(54.6' - 99.9' - 88.5') PRESTRESSED CONCRETE NU GIRDER SPANS (SKEW VARIES)

BRIDGE NO. A9542

REV. 1 - NDC-002 - REVISED DIMENSIONS

BRIDGE: I-70 EB OVER HINKSON CREEK

DETAILS OF END BENT 1

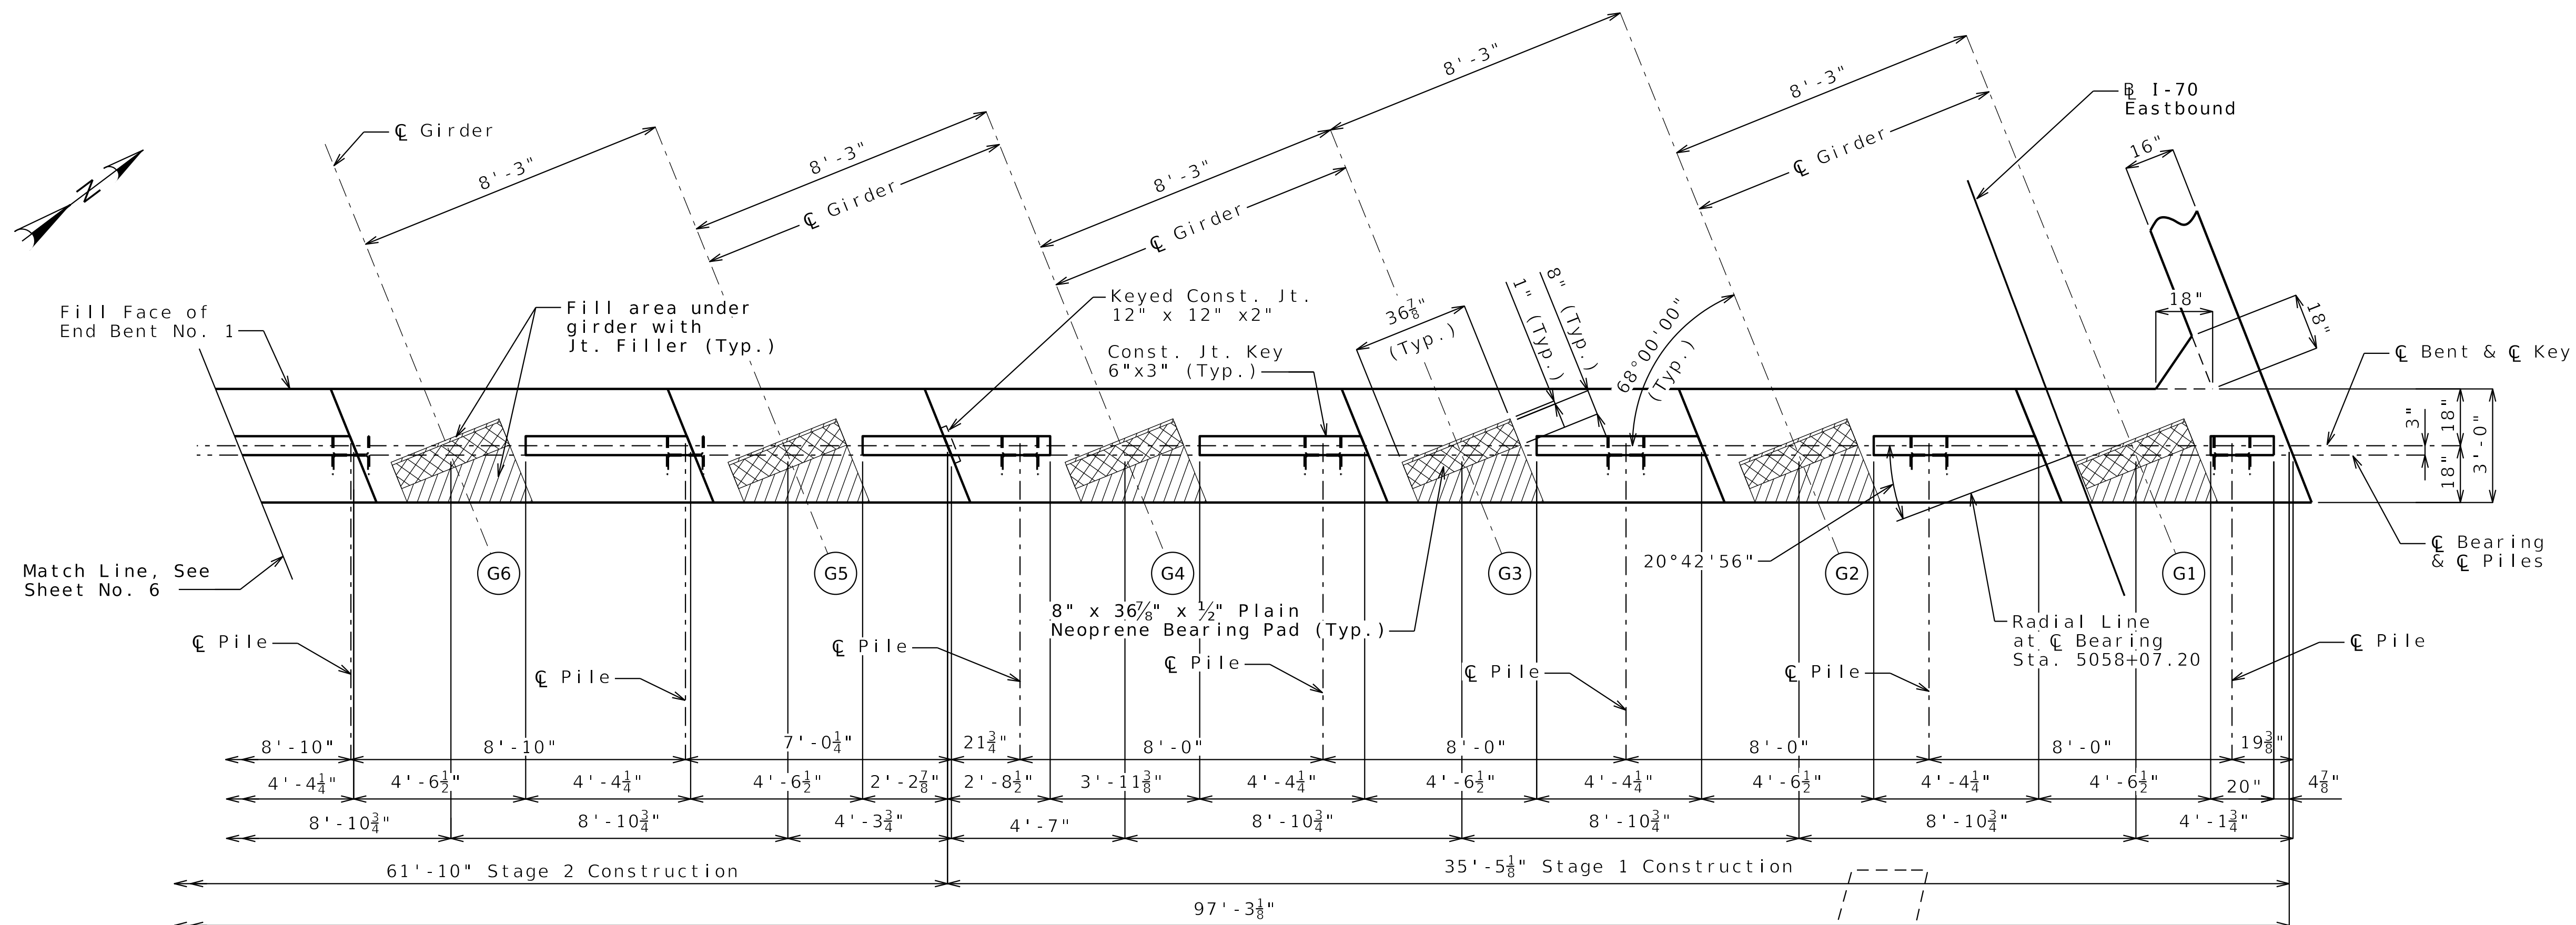
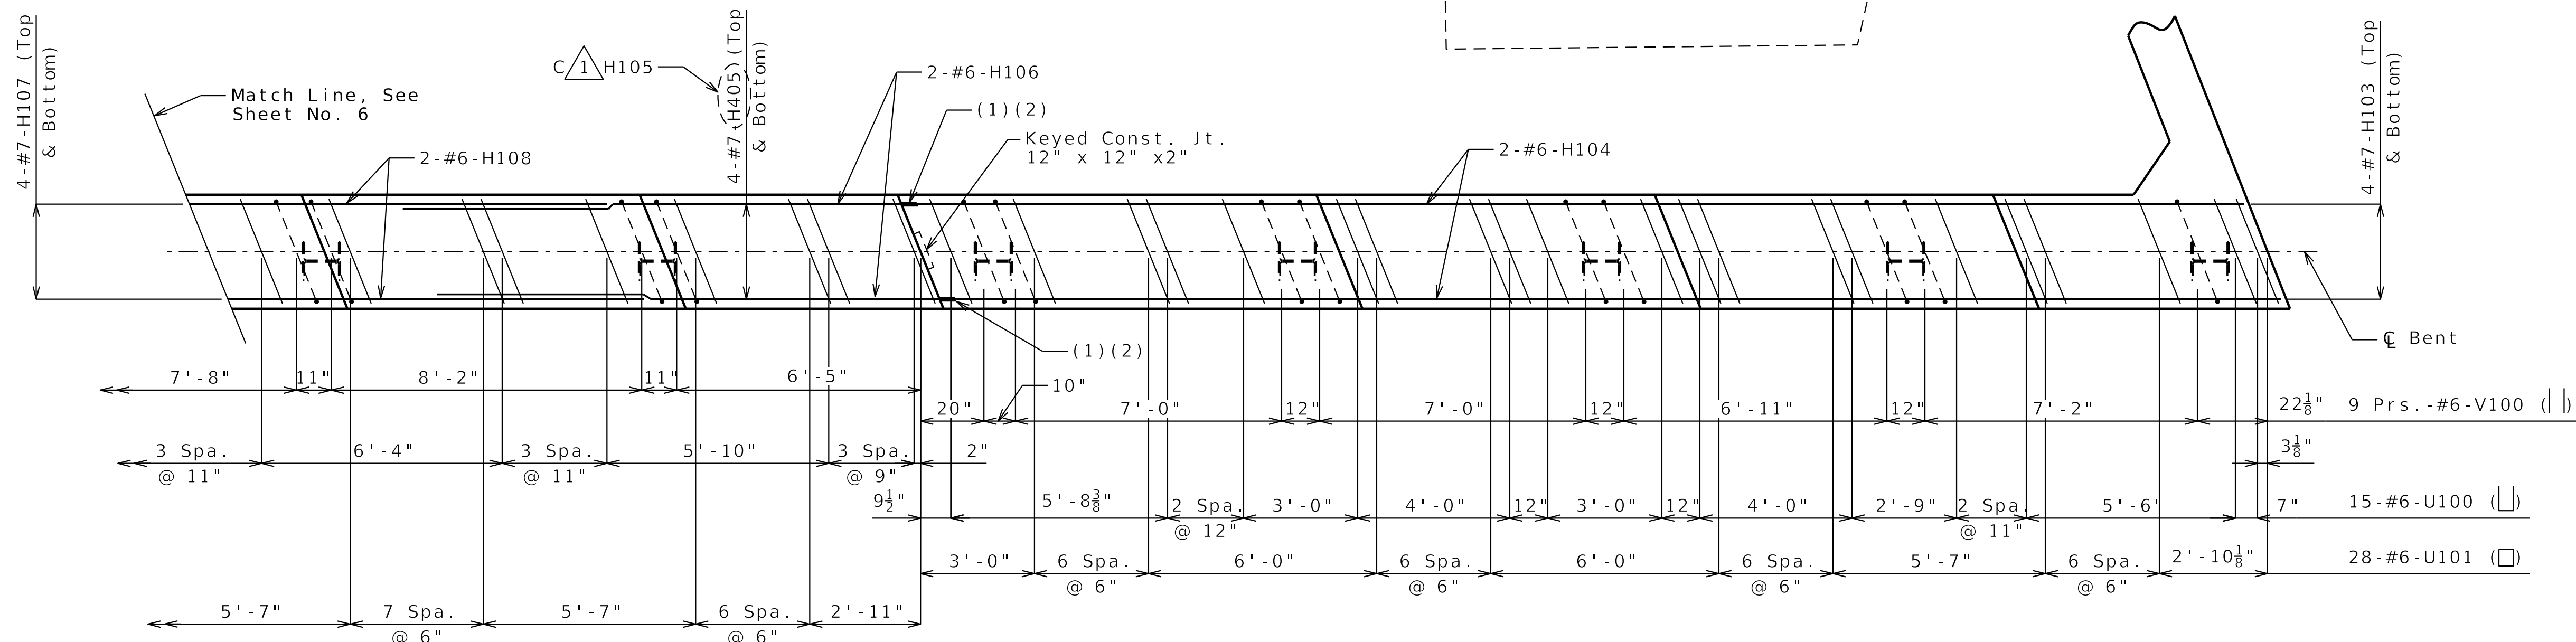
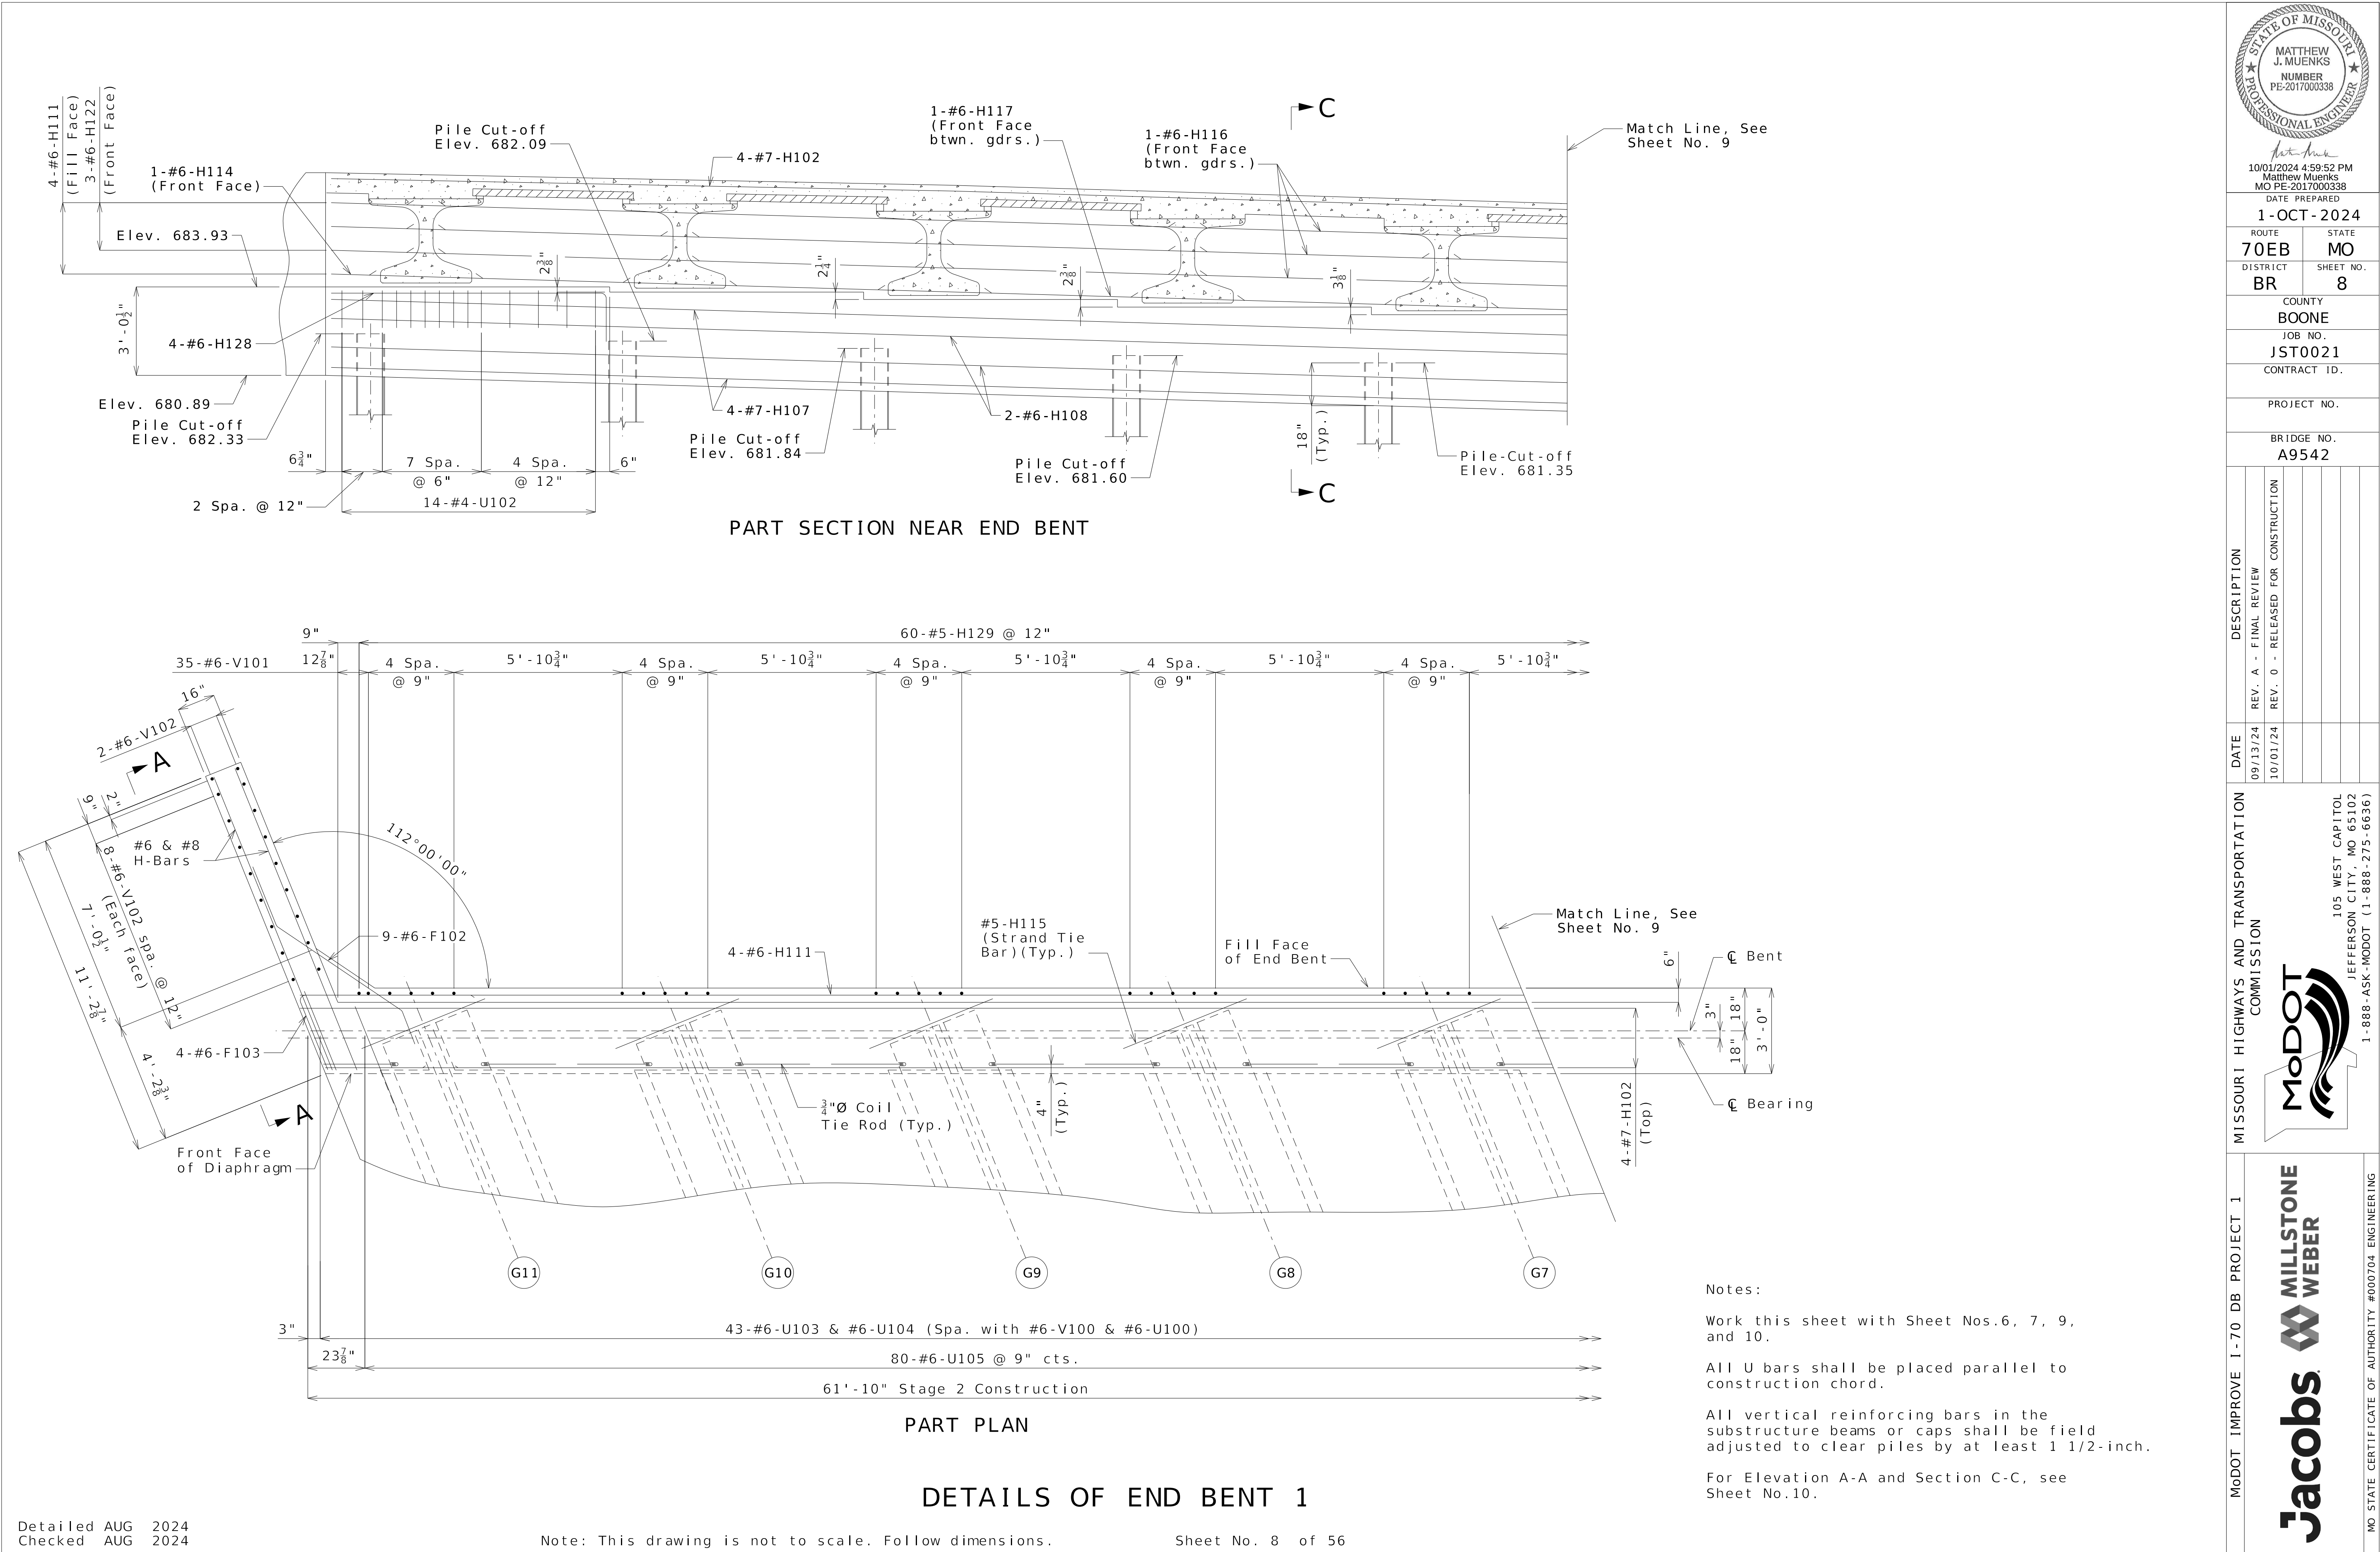
REV. 1 - NDC-002 - REVISED REINFORCING
